Status: Y N U **Area Walk-By Checklist (AWC)**Location: Bldg. DIESEL Floor El. 130 Room, Area¹ SWITCHGEAR ROOM 2F**Instructions for Completing Checklist**

Status: Y N U **Area Walk-By Checklist (AWC)**Location: Bldg. REACTOR Floor El. 87 Room, Area¹ Unit 2 HPCI Room**Instructions for Completing Checklist**

Figure 8 – Loose Bent Steel Support (Unit 2 87' NE Diagonal)

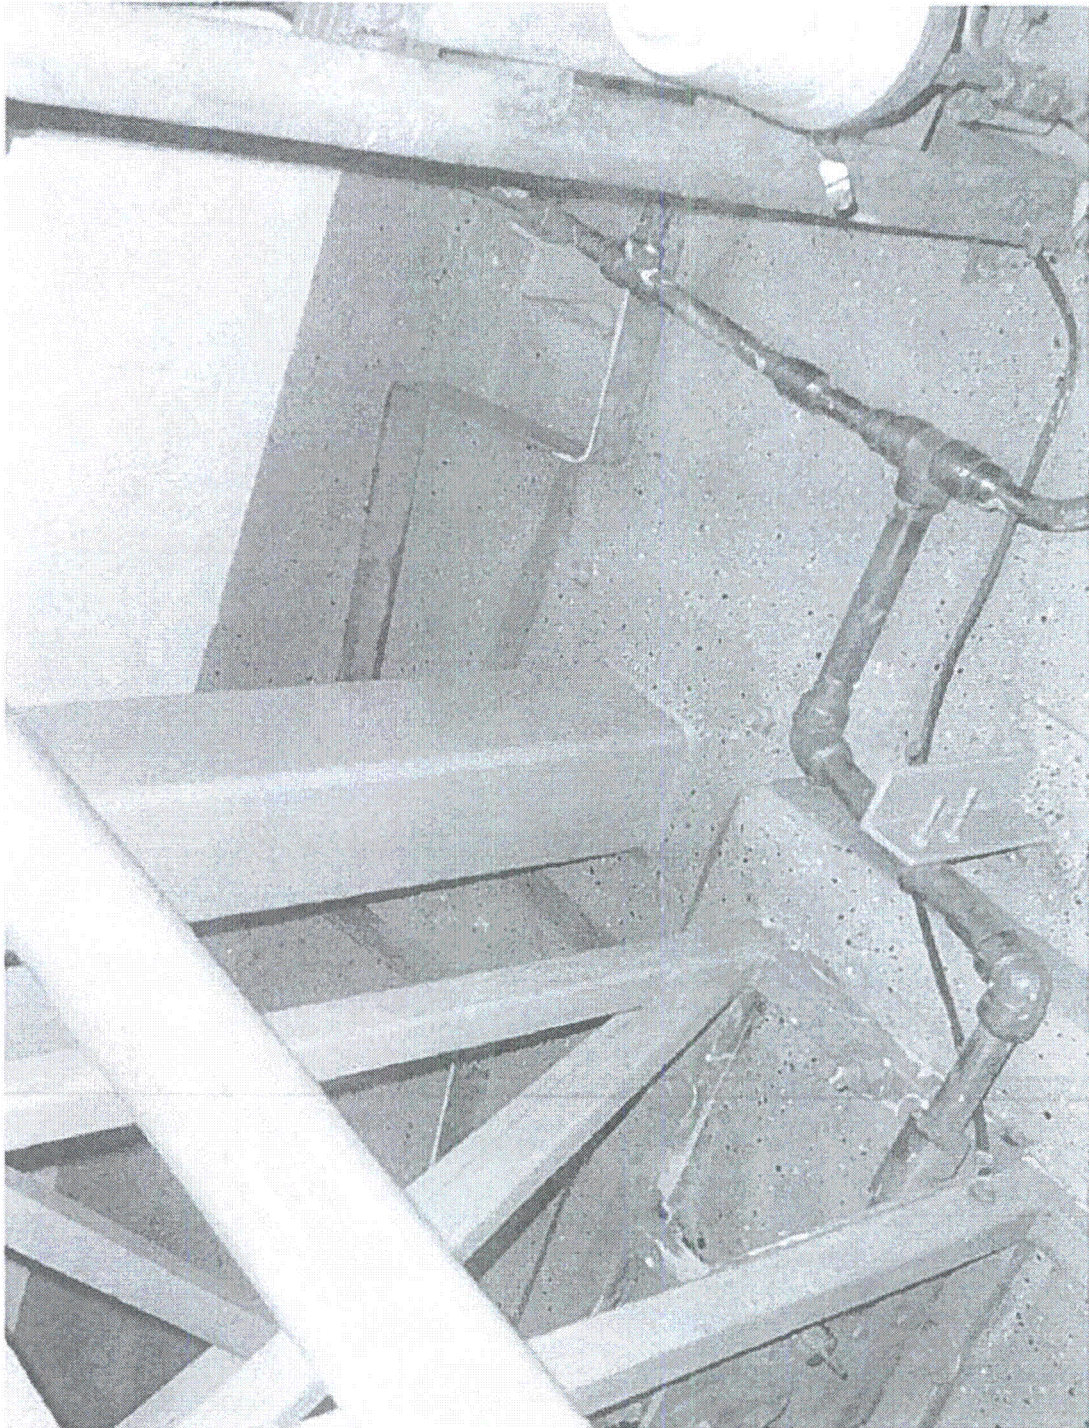
There was a 3' long bent steel support that was sitting on the floor next to the 2H21-P001 instrument rack (CR 523087). The support is small and light, and is not located near any sensitive equipment, so it is judged that there is no potentially adverse seismic condition. It was not readily apparent where the support belonged or whether it needed to be reinstalled.

1: Spalled Concrete Bearing Pad for Storage Tank (Diesel Building Roof – North End)

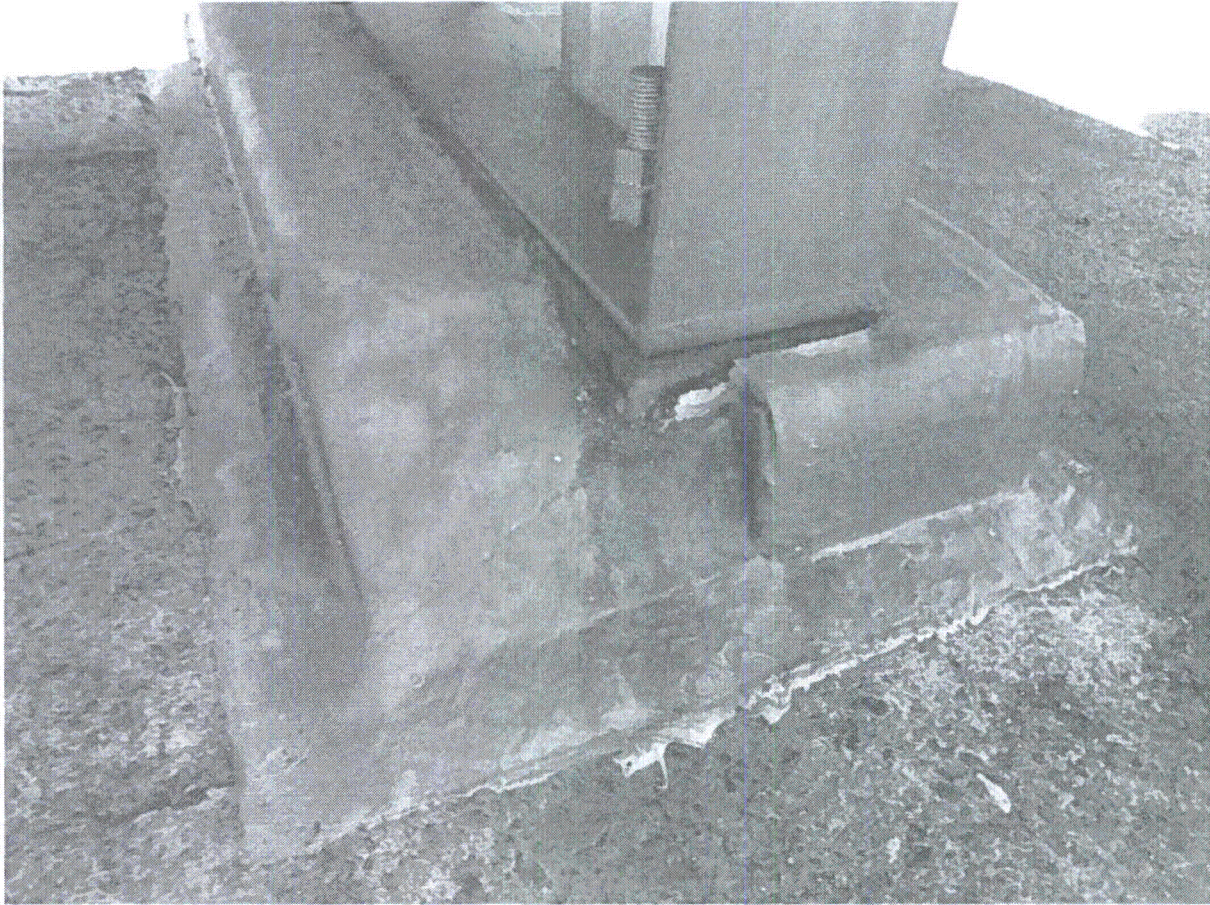
2. Does anchorage of equipment in the area appear to be free of significant degraded conditions? Y N U N/A
Concrete bearing pad of storage tank located 2nd from the north end of the roof exhibits spalled corners (see photograph 1). This is typical on all four ends of the pads. Grout pads are not structural. The bearing plate is well supported and the bolts fully extend into the concrete below the grout. The grout is not considered in the bolt capacity. Therefore, the concrete pads are judged to be seismically adequate.

2: U Bolt Not Securely Fastened to Angle Support (Diesel Building Roof – North End)

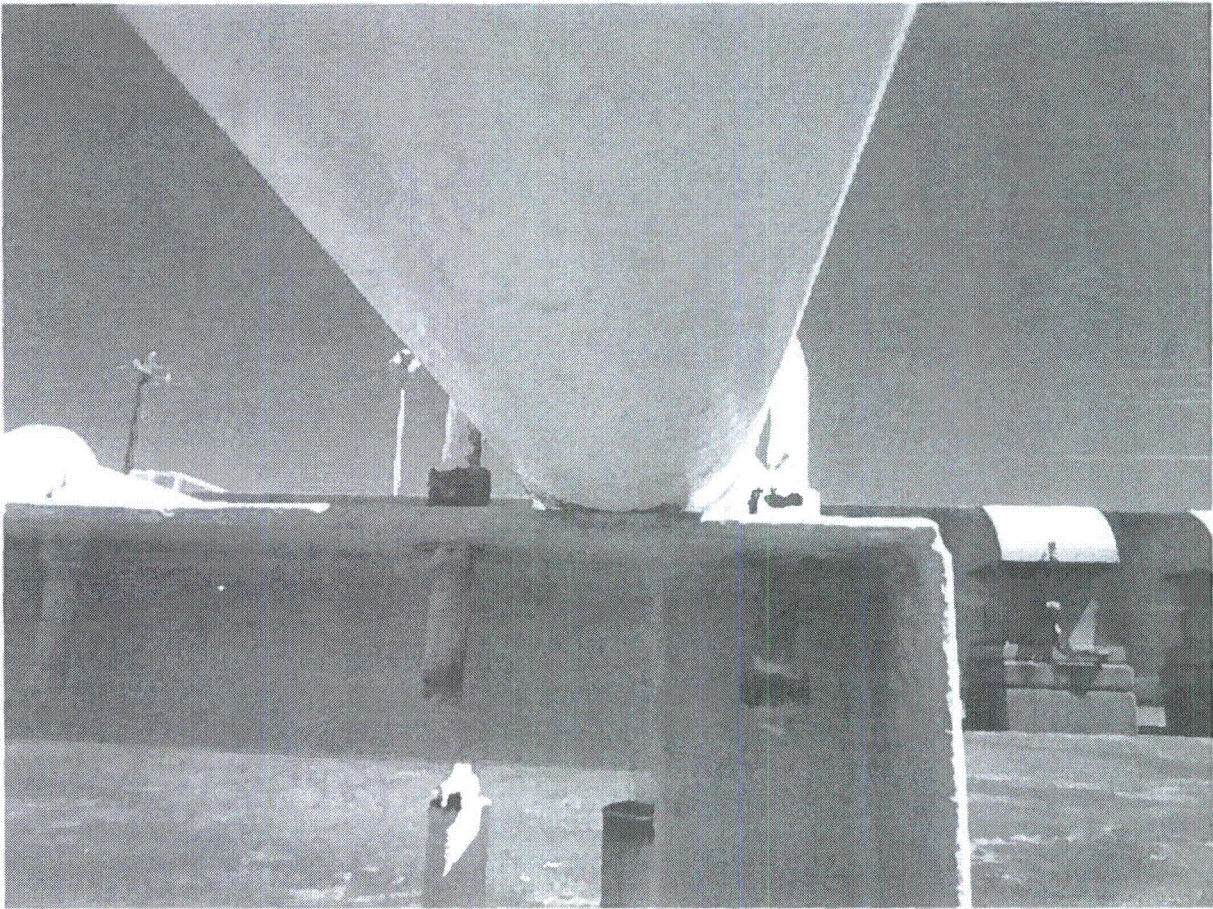
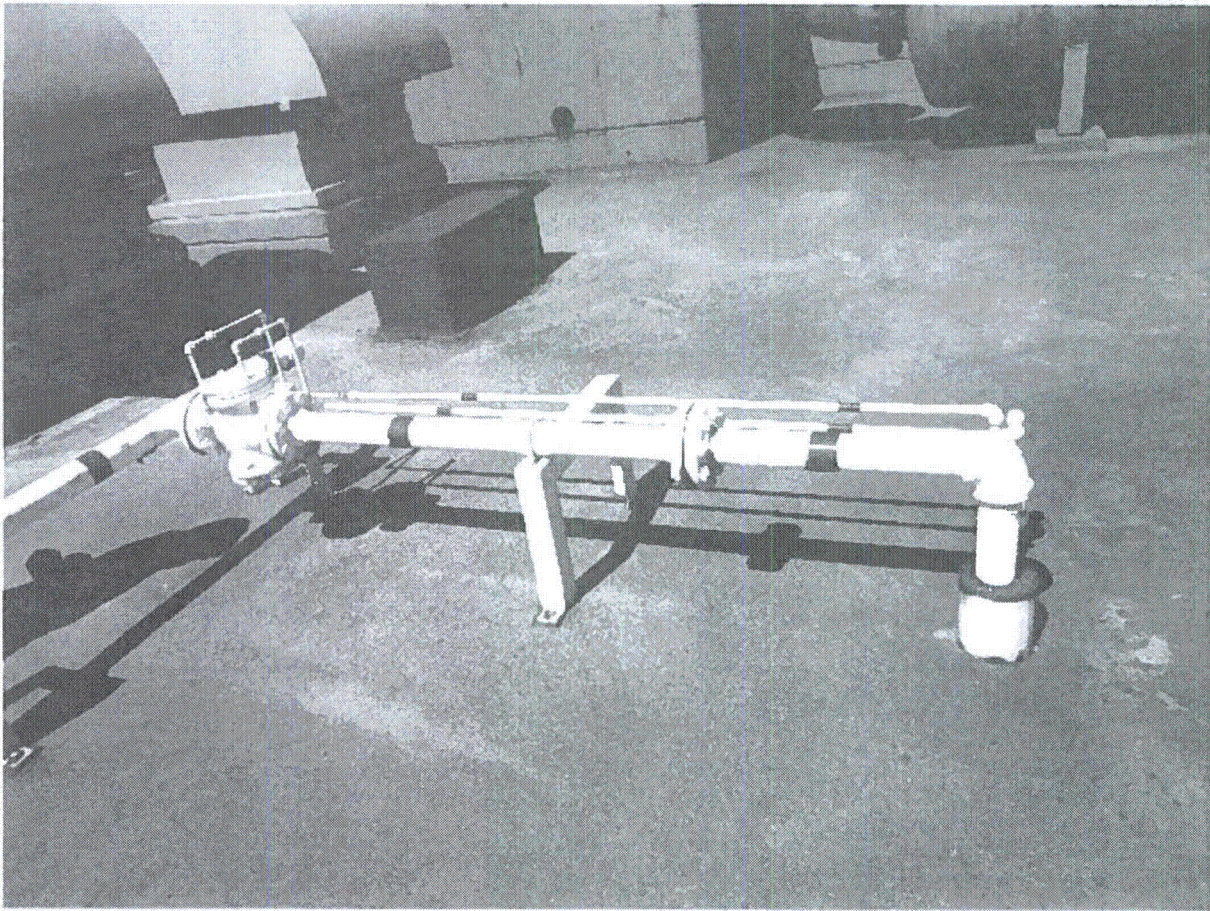
8. Have you looked for and found no other seismic conditions that could adversely affect the safety functions of the equipment in the area? Y N U
There is a U bolt support for a fire protection pipe (see photographs 2 and 3) which is not securely fastened to the angle support. A nut is missing and another is not tightened. The pipe is supported vertically but the angle support and the U bolt in place to prevent the pipe from moving off the support laterally. Vertical seismic accelerations are not great enough for the bolt to be lifted out of place. It is judged to be seismically adequate. CR 523486 has been written to replace the missing/unsecured nuts.

Figure 1 – Loose Nozzles near Bottles (Near Equipment Hatch Unit 2)

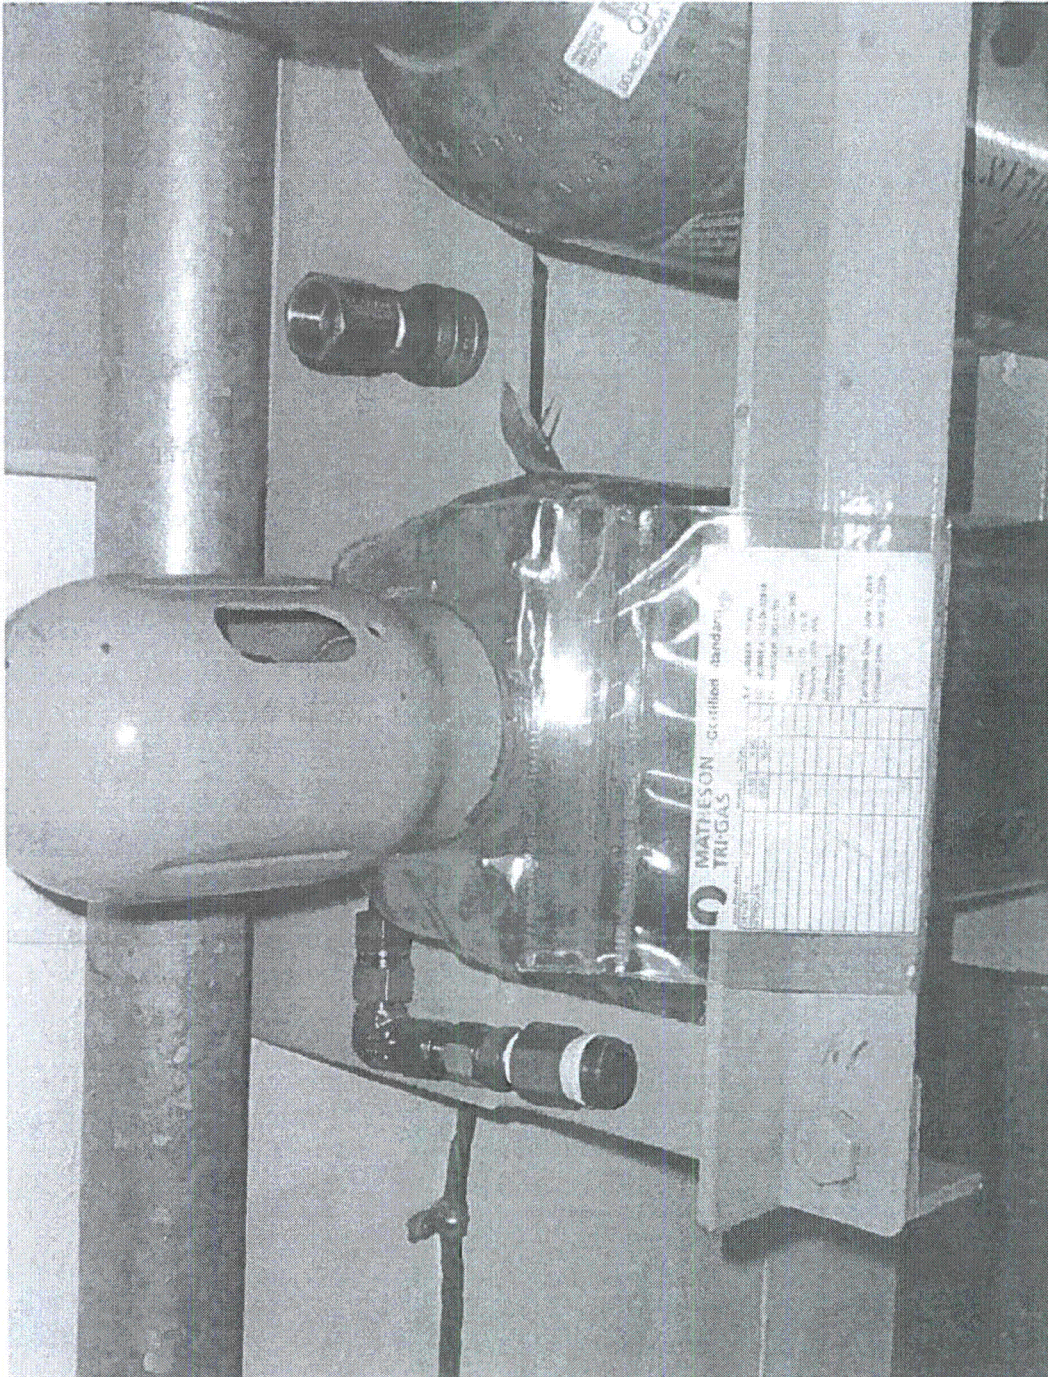
There are two brass nozzles sitting loose on top of the Gas Cylinder Location 2P33-P066 and two brass nozzles sitting on the frame for panel 2H21-P405B, which is a high potential to cause a plant transient (CR 515750). The nozzles are small and relatively light, so they are unlikely to cause any structural damage during a seismic event. However, due to their location on the support for a high trip hazard panel, there is a concern that the nozzles could potentially cause a plant transient.
